**TAMPA-HILLSBOROUGH COUNTY
EXPRESSWAY AUTHORITY**

Addendum No. 11

East Selmon Slip Ramps Design-Build

DATE OF ADDENDUM: March 11, 2021

A_010 – Pipe Lining Locations (Updated March 11, 2021)

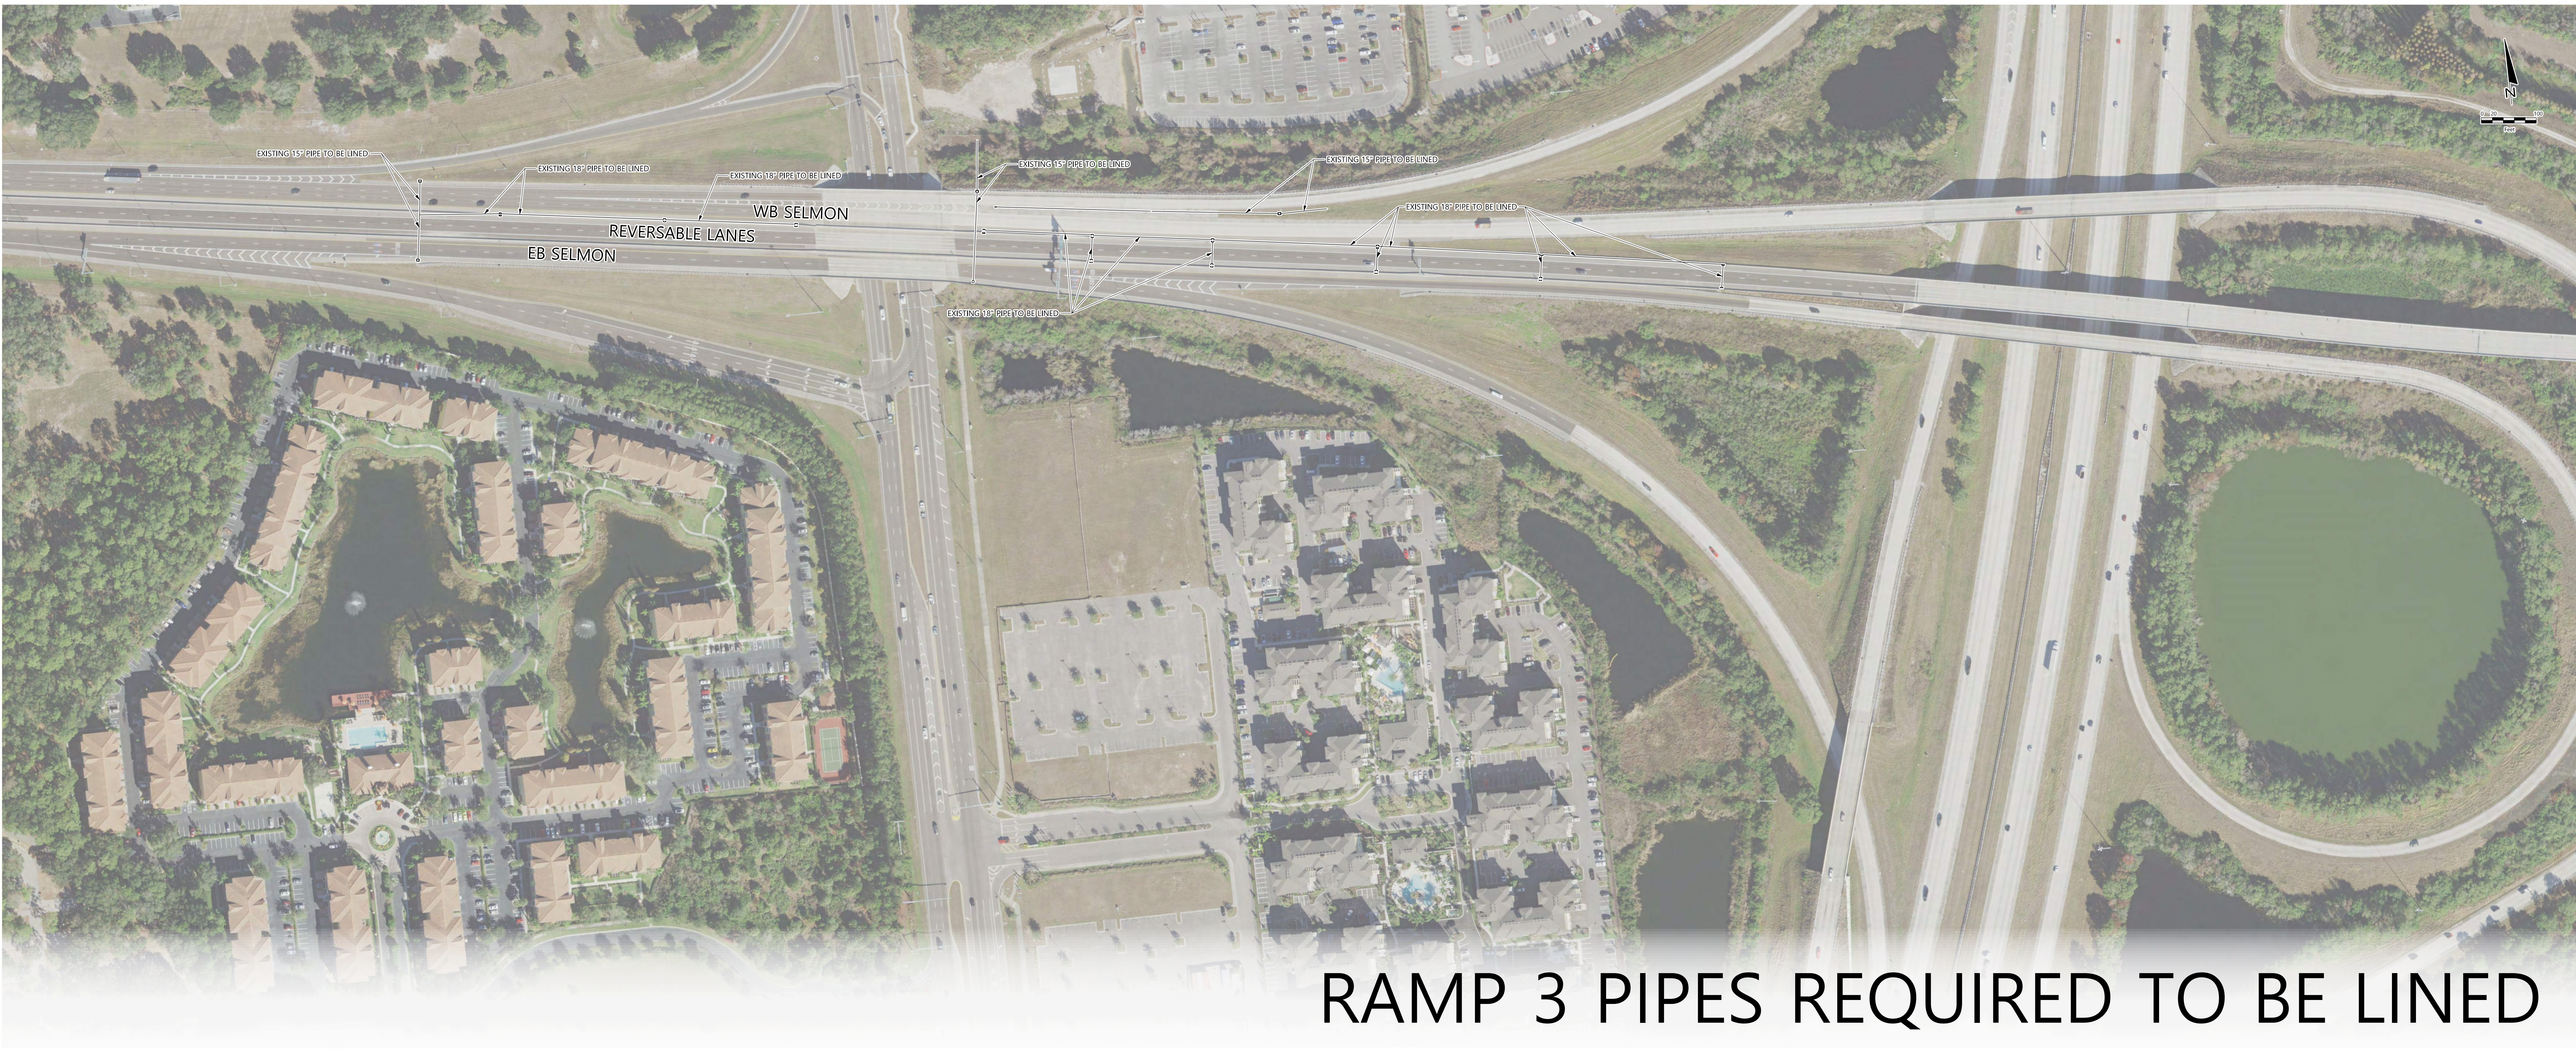
EXISTING 18" PIPE TO BE LINED

EXISTING 15" PIPE TO BE LINED

EXISTING 18" PIPE TO BE LINED

EXISTING 24" PIPE TO BE LINED

EXISTING 18" PIPE TO BE LINED

RAMP 2 PIPES REQUIRED TO BE LINED

RAMP 3 PIPES REQUIRED TO BE LINED
